# FOUNDATION INVESTIGATION REPORT

Mattawasaga River Bridge  
Hwy. 101, District 14, New Liskeard  
W.P. 68-70-2201

FOUNDATION INVESTIGATION REPORT  
For  
Mattawasaga River Structure  
Highway #101  
District No. 14 (New Liskeard)  
W.O. 70-11072 -- W.P. 68-70-01

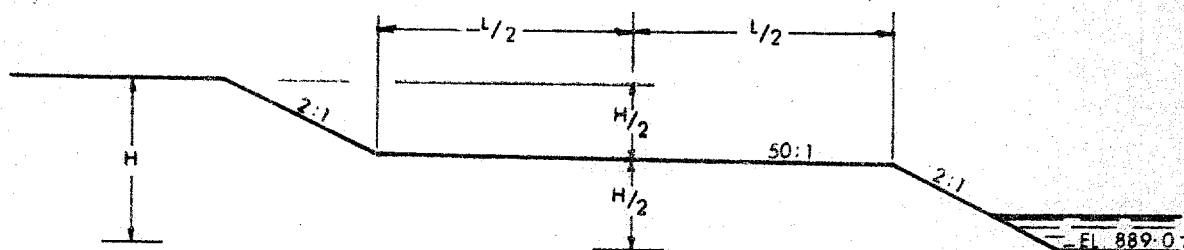
(1) Due to the fact that the original ground is some 3 to 5 feet higher than the level at the edge of the existing river bank a cut some 13 to 14 feet deep would be required for the proposed diversion channel. Assuming soil conditions along the diversion to be similar to those at the culvert site (B.H. #7), the new channel would require extensive benching to ensure stability. The exact dimensions of these benches can not be determined until a contoured plan of the proposed diversion is available, but it is obvious that they would add considerably to the cost of the job.

(a) Remove material from behind existing abutments to conform with sketch on Page 3.

(d) Place filter blanket on slopes and rip rap. Sufficient rip rap must be placed at this time in the river bed to prevent scour, or the stability of the slopes, and hence also of the structure will be endangered. This latter point should be referred to the Bridge Hydrology Engineer.

(e) Drive piles and construct new bridge.

Due to the fact that a somewhat lower grade would be possible at the site of the existing structure shorter berms than are shown on Fig. 7A would be required. The exact length of berm required may be interpolated from the graph on Page 3. It should be noted that the height H is the difference between elevation of stream bed and the elevation of the road  $\phi$  just behind the bridge abutment.

Since a temporary detour will be required during construction of the new bridge we suggest that consideration be given to re-aligning the highway so that the new structure may be built alongside the existing one in two stages. We believe that a line shift of about 25 ft. would achieve the required result in this case. If it is decided to construct a separate detour with a Bailey bridge, it will be necessary to comply with recommendations given above for the stability of the approaches to the temporary crossing. The Bailey bridge may be supported on rock-filled cribs placed on the original ground (after removal of organic soil) assuming a safe bearing capacity of 600 p.s.f. It will be necessary to carry out further stability analyses, however, and this will be done as soon as we are supplied with specific proposals, including a profile along the  $\phi$  of the proposed detour.

LONGITUDINAL SECTION

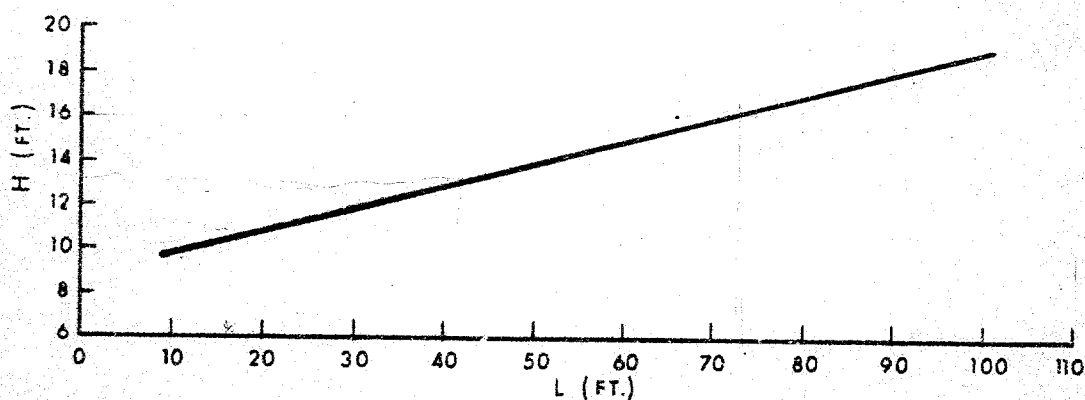
HEIGHT OF EMBANKMENT  $H$  versus BERM LENGTH  $L$

It should be noted that recommendations given in this memorandum supercede those given in our original report #70-11072.

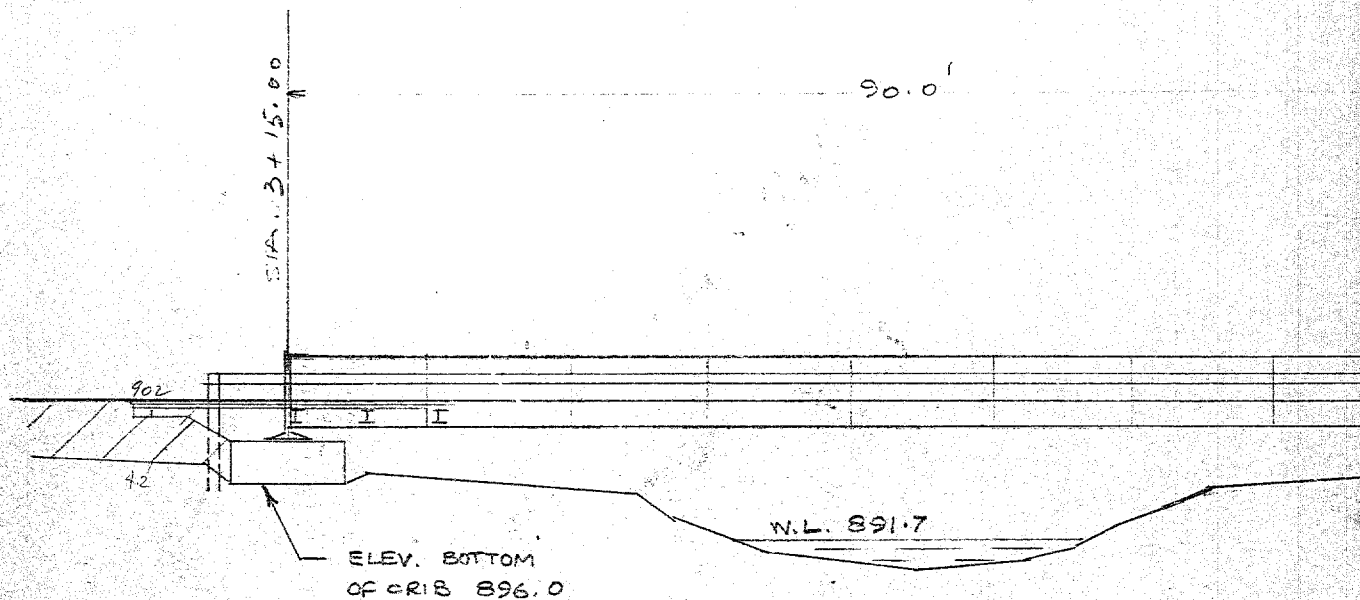
We have reviewed your Drawing 39-155-1 for the above-mentioned project. The Bailey Bridge appears to have been designed in accordance with our memorandum of June 25, 1973, and there should be no problems.

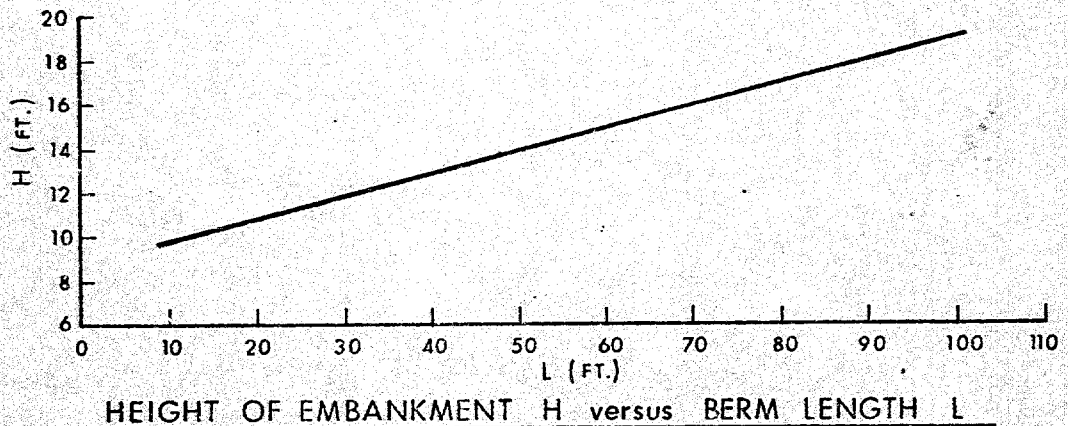
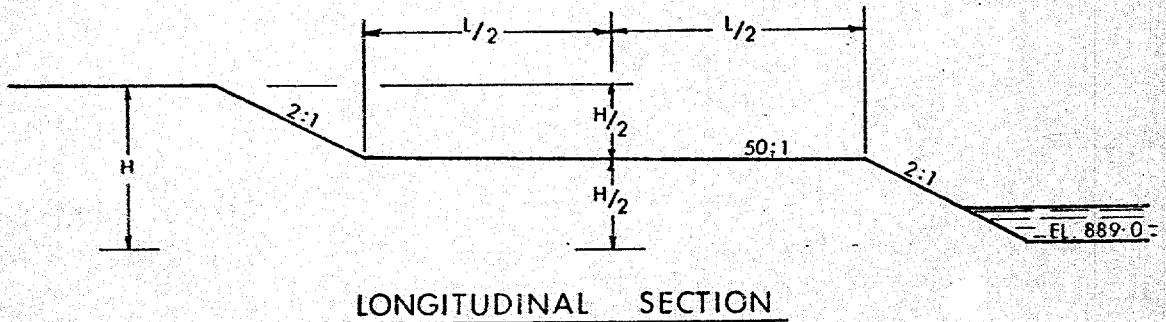
(1) Due to the fact that the original ground is some 3 to 5 feet higher than the level at the edge of the existing river bank a cut some 13 to 14 feet deep would be required for the proposed diversion channel. Assuming soil conditions along the diversion to be similar to those at the culvert site (B.H. #7), the new channel would require extensive benching to ensure stability. The exact dimensions of these benches can not be determined until a contoured plan of the proposed diversion is available, but it is obvious that they would add considerably to the cost of the job.

(a) Remove material from behind existing abutments to conform with sketch on Page 3.

(d) Place filter blanket on slopes and rip rap. Sufficient rip rap must be placed at this time in the river bed to prevent scour, or the stability of the slopes, and hence also of the structure will be endangered. This latter point should be referred to the Bridge Hydrology Engineer.

(e) Drive piles and construct new bridge.

Due to the fact that a somewhat lower grade would be possible at the site of the existing structure shorter berms than are shown on Fig. 7A would be required. The exact length of berm required may be interpolated from the graph on Page 3. It should be noted that the height H is the difference between elevation of stream bed and the elevation of the road  $\phi$  just behind the bridge abutment.

Since a temporary detour will be required during construction of the new bridge we suggest that consideration be given to re-aligning the highway so that the new structure may be built alongside the existing one in two stages. We believe that a line shift of about 25 ft. would achieve the required result in this case. If it is decided to construct a separate detour with a Bailey bridge, it will be necessary to comply with recommendations given above for the stability of the approaches to the temporary crossing. The Bailey bridge may be supported on rock-filled cribs placed on the original ground (after removal of organic soil) assuming a safe bearing capacity of 600 p.s.f. It will be necessary to carry out further stability analyses, however, and this will be done as soon as we are supplied with specific proposals, including a profile along the  $\phi$  of the proposed detour.
